INITIAL FIRE SAFETY INSPECTION REPORT

A.K.M. KNIT WEAR LTD. (Extension)

RSC ID: 25607

Date: 24 March-2024

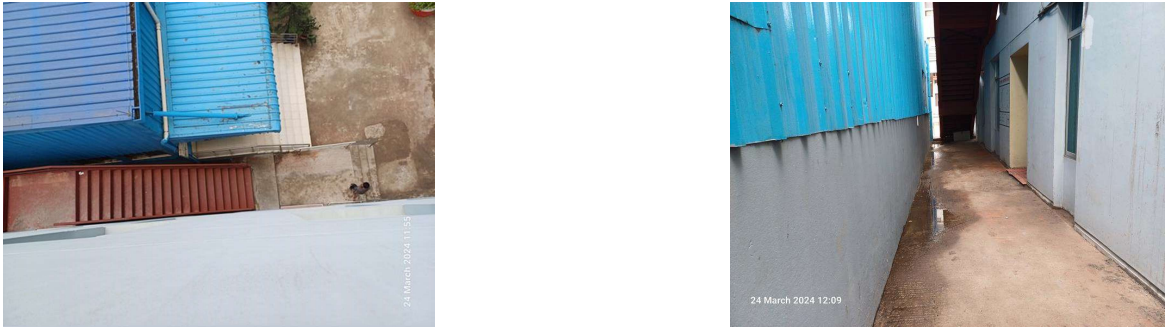
F-02	Fire Rated Construction	The exit stair is not separated from other occupancy due to the non-rated construction at child care building and non-functionality of the hardware of the fire rated door. Furthermore, the gap beneath the fire rated door has been found more than 19 mm at utility building. Some fire doors installation is underway.	Ensure that the fire doors are self-closing and positive latching and that they are provided with fire exit (panic) hardware where serving production floors. If fire doors are required to be held open for functional reasons, provide automatic closing devices tied to the fire alarm system. The clearance under the bottom of a fire door shall be a maximum of 19 mm. From edges and top shall be limited to a maximum 4.8 mm. All measurement shall be taken from the ""pull side"" of the door. Any modification of fire doors beyond the job site preparation shall be approved by the door manufacturer. Install the fire door as per NFPA 80. Factory shall ensure the integrity of the functionality of the fire rated door through proper datasheet, certificate and listing label.	Within 3 Months

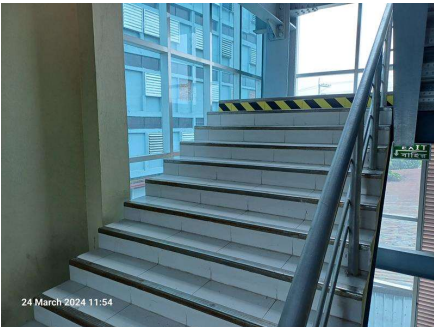
F-04	Fire rated Construction	Ground floor exit-3 discharge path width of child care building is less than 10 feet and not separated from the surrounding building openings.	An egress court serving as a portion of the exit discharge shall be open to the sky or provided with a fire resistance rated enclosure the same as the exit enclosure. Egress courts less than 3050 mm (10 ft) in width (as measured from the building and the adjacent property line) shall be provided with walls having a 1-hr fire resistance rated construction for a distance of 3050 mm (10 ft) above the floor of the court.	Within 3 Months
------	-------------------------	--	---	-----------------
